## Technical change to RS RD/RI Interfaces

PCN-number: 20231220

Example of DEKAFIX detail

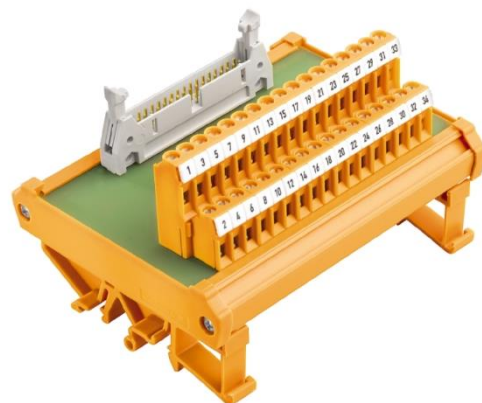
Articles on Section 5 were delivered in the past with LP 5.08, LP1N 5.08 and LP2N 5.08 connectors. In addition, they were delivered with Dekafix\*

\*Dekafix is the universal marker for terminals, plug-in connectors and electronic modules from the Weidmüller product range (see detail).

## 2. Technical change

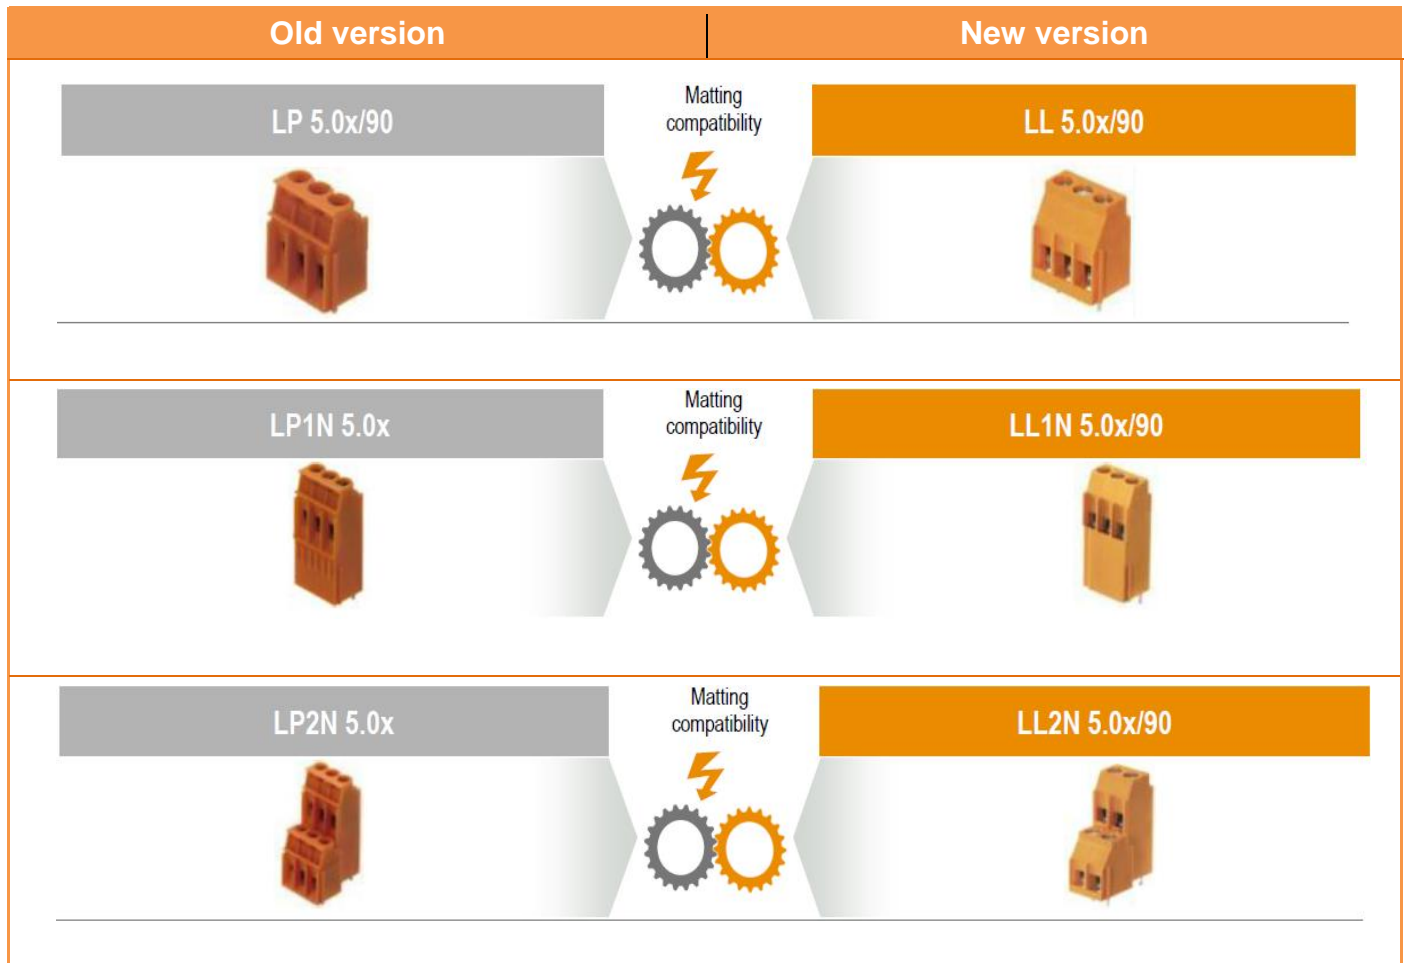
Based on continuous improvement, the LP family connectors mentioned in Section 1 will be replaced by LL family connectors.  
Furthermore, all the connectors will be marked with KSW strip markers.
